Addendum No. 3
August 2, 2024

Project: Brandon Valley Elementary School
Brandon, South Dakota
Project #3023

Architect: Architecture Incorporated

FLOOR PLAN - AREA B - PLUMBING & HEATING

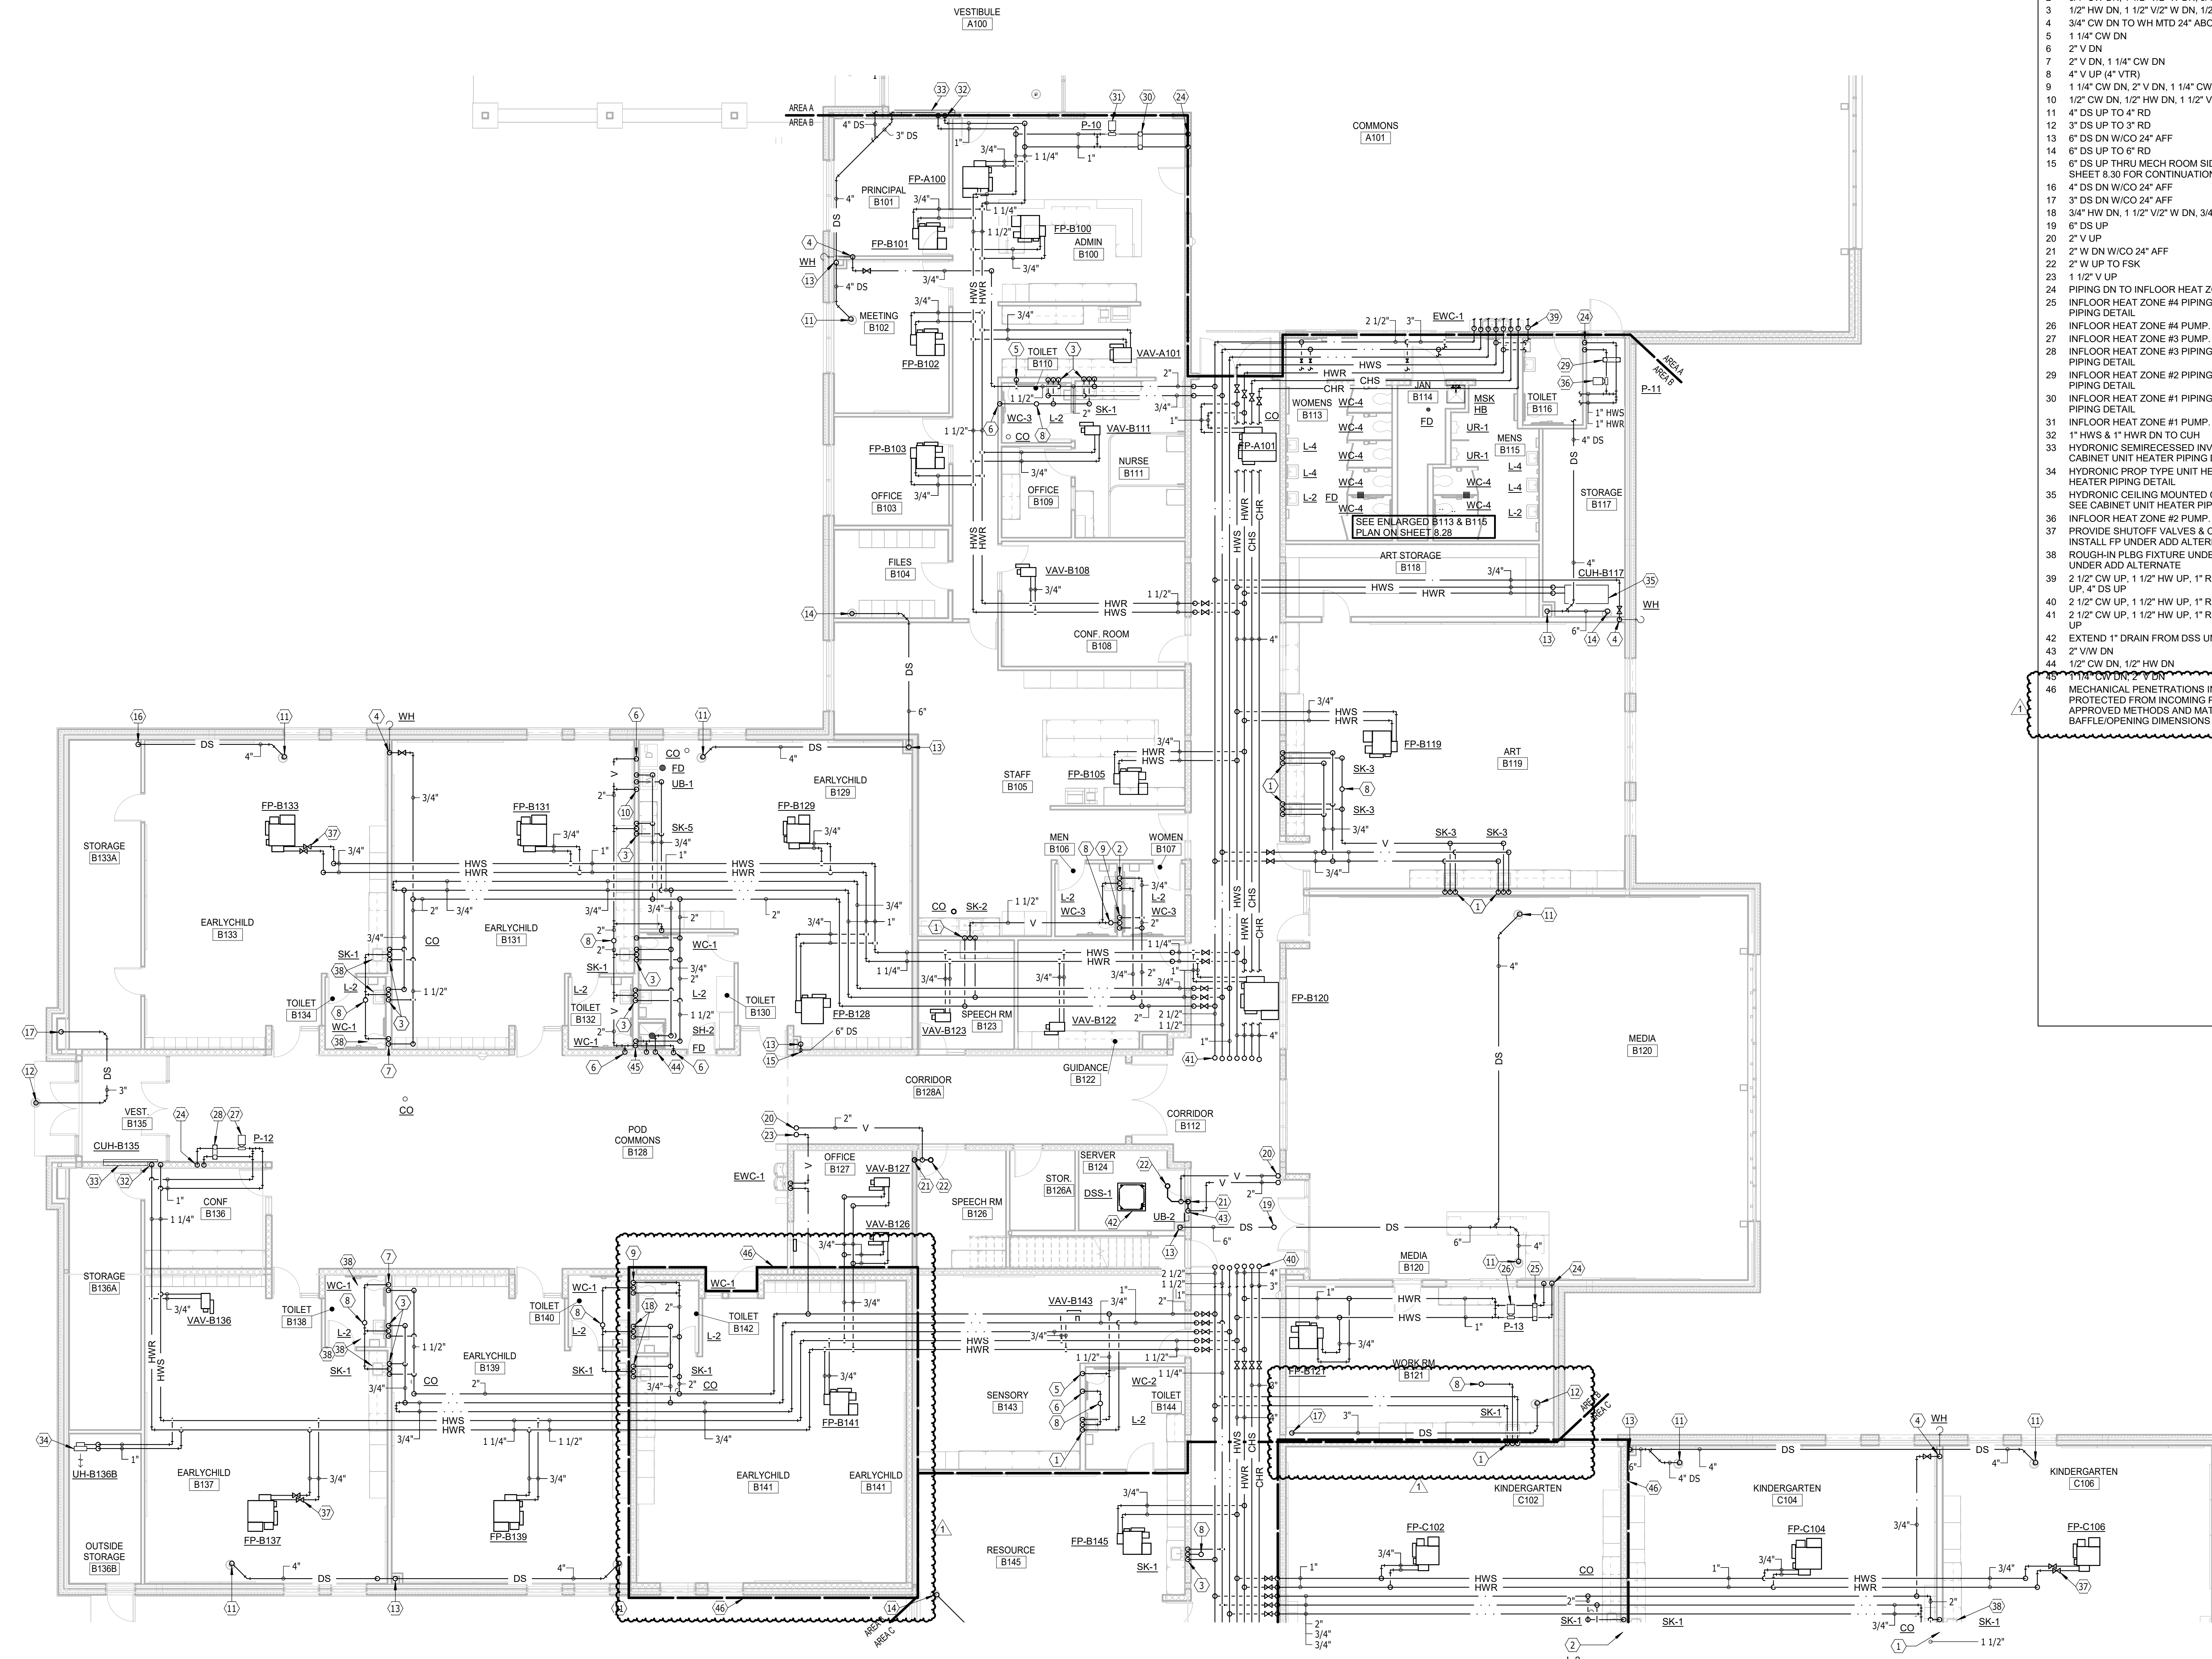
- 49) SHEET 8.25 – FLOOR PLAN -AREA B – PLUMBING & HEATING
- a) Reference *revised* sheet 8.25, revision dated 8-1-2024 attached to the end of Addendum #3 for the following modifications:

- 1) Add note regarding mechanical penetrations of a storm shelter; refer to *revised* drawing sheet 8.25, Addendum #3, dated 8-1-24.
- 50) SHEET 8.26 – FLOOR PLAN - AREA C – PLUMBING & HEATING

ENLARGED KITCHEN FLOOR PLAN - AREA A - PLUMBING & HEATING

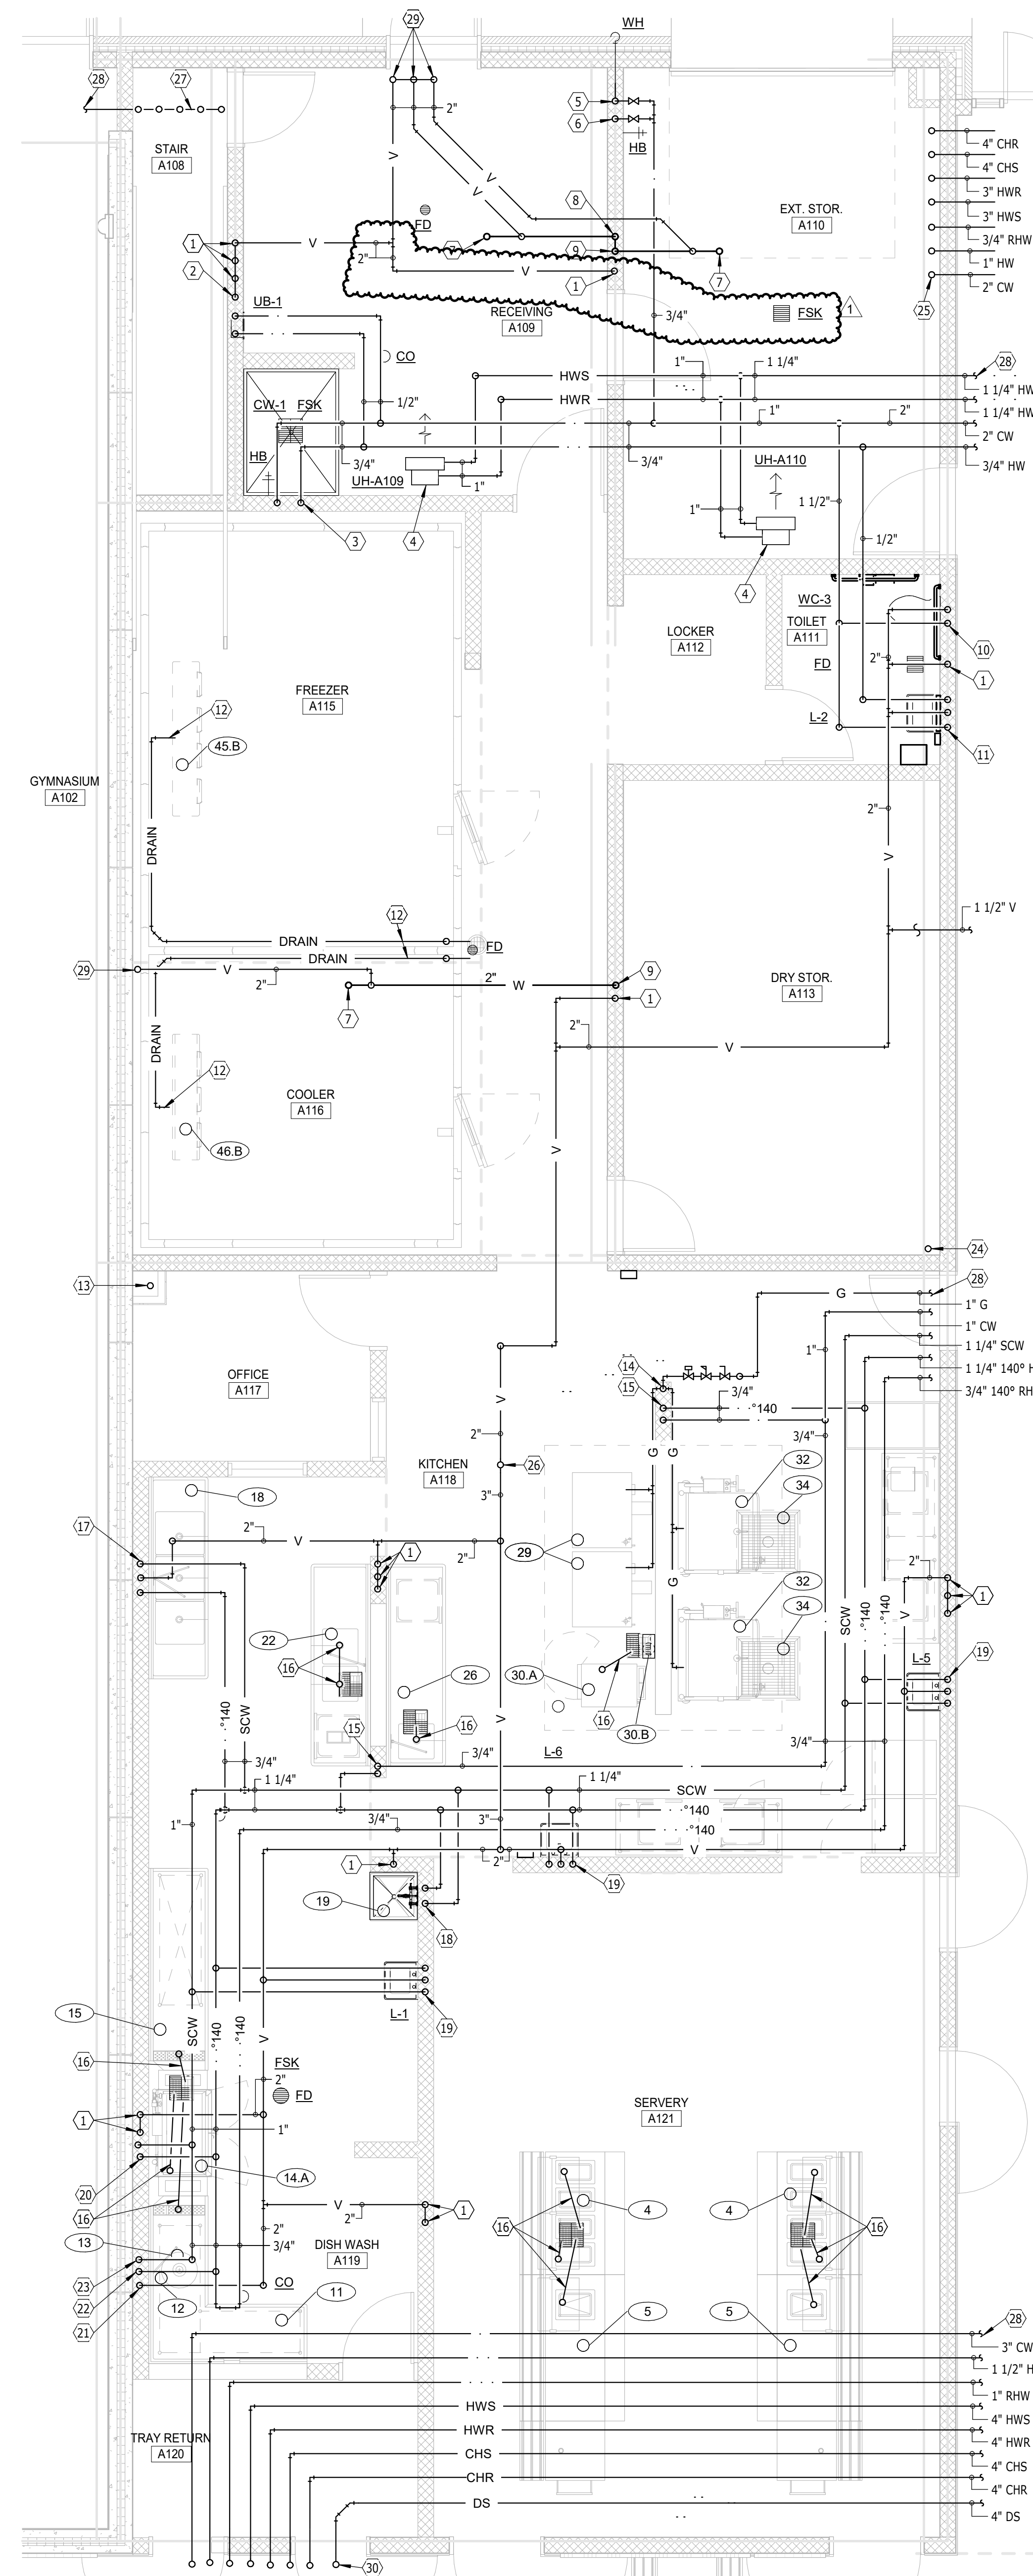
- 52) SHEET 8.29 – ENLARGED KITCHEN FLOOR PLAN - AREA A – PLUMBING & HEATING
- a) Reference *revised* sheet 8.29, *revision* dated 8-1-2024 attached to the end of Addendum #3 for the following modifications:

FLOOR PLAN - AREA D - POWER & SIGNAL
SCALE 1/4" = 1'-0"

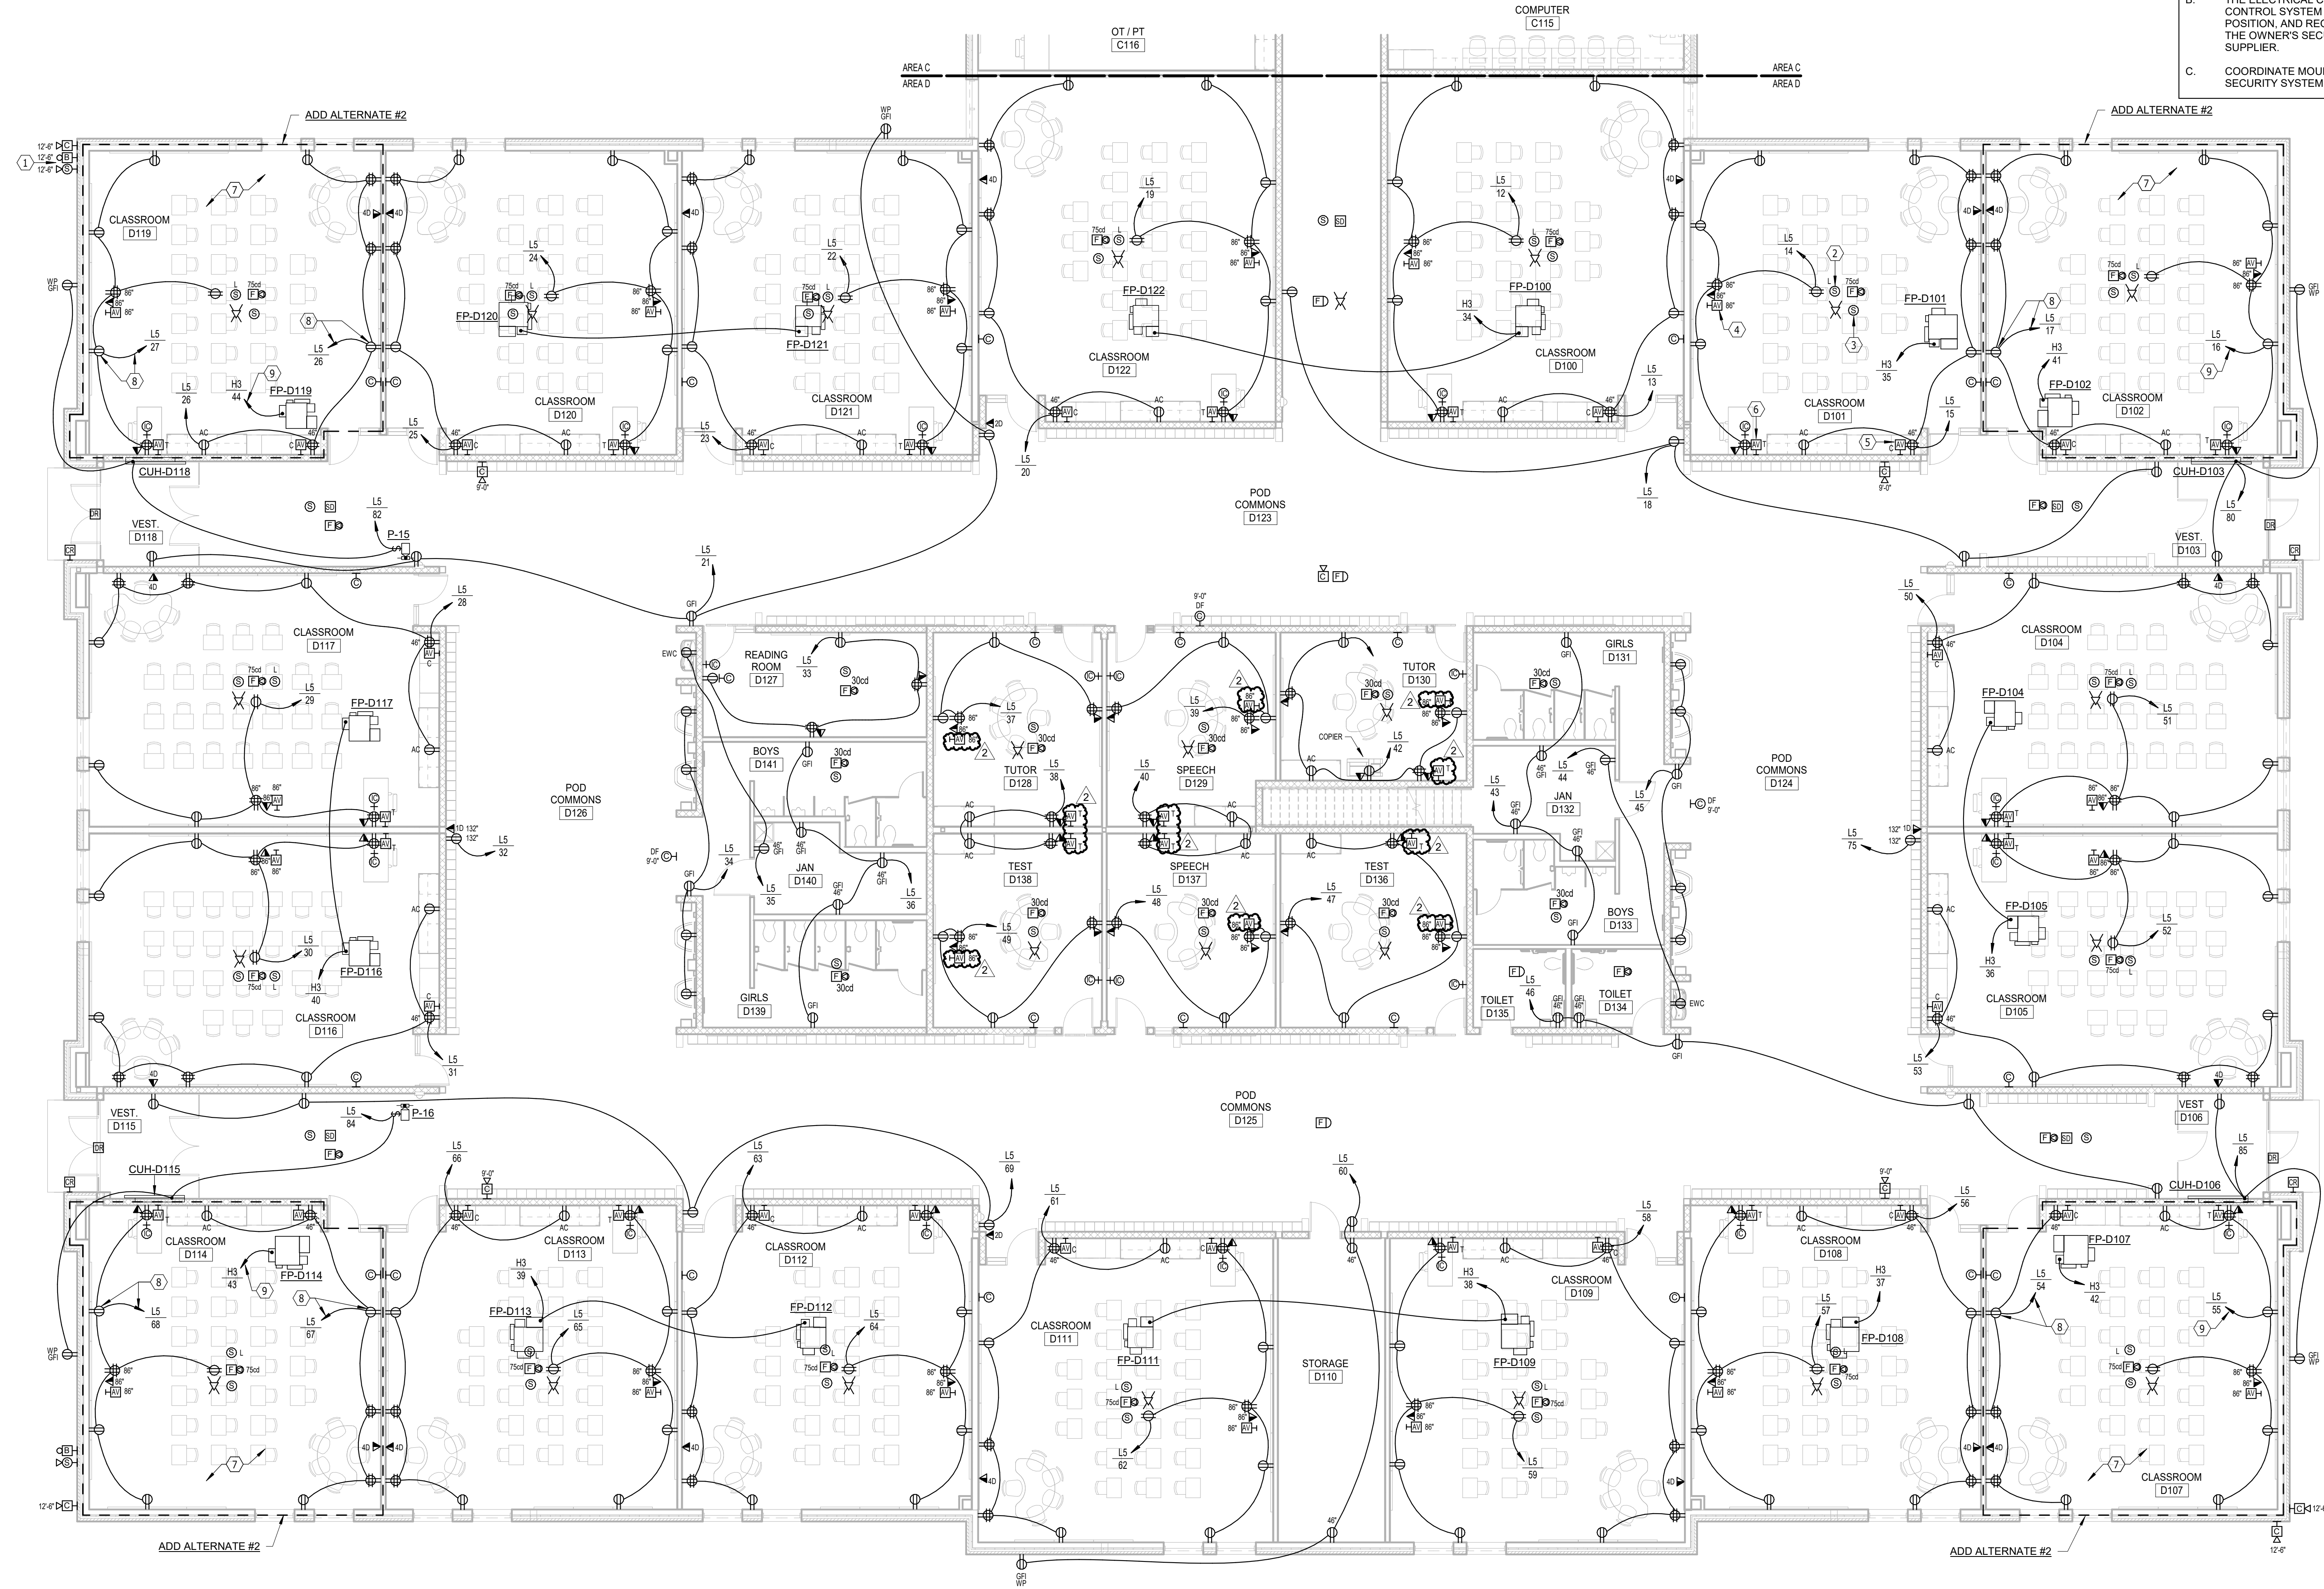
- 55) SHEET 9.28 – AREA D - POWER & SIGNAL
 - a) Reference *revised* Sheet 9.28 *revision* dated 8-1-2024, attached to the end of Addendum #3 for the high and low AV outlets added in Rooms D128, D129, D130, D136, D137, and D138.
- 56) SHEET 9.41 – ENLARGED PLANS - ELECTRICAL
 - a) Reference *revised* Sheet 9.41, *revision* dated 8-1-2024, attached to the end of Addendum #3 for the CT cabinet added on the exterior west wall of the room *A123* – as indicated.
- 57) SHEET 9.56 – ELECTRICAL DETAILS
 - a) Revise A/V details as indicated in the *revised* Sheet 9.56, *revision* dated 8-1-2024, attached to the end of Addendum #3.
- 58) SHEET G9.20 – BUS GARAGE FLOOR PLAN – ELECTRICAL – ADD ALTERNATE #1
 - a) The has been revised to read Reference *revised* Sheet G9.20, *revision* dated 8-1-2024, attached to the end of Addendum #3 for the *revised* electrical note # 8 – as indicated.
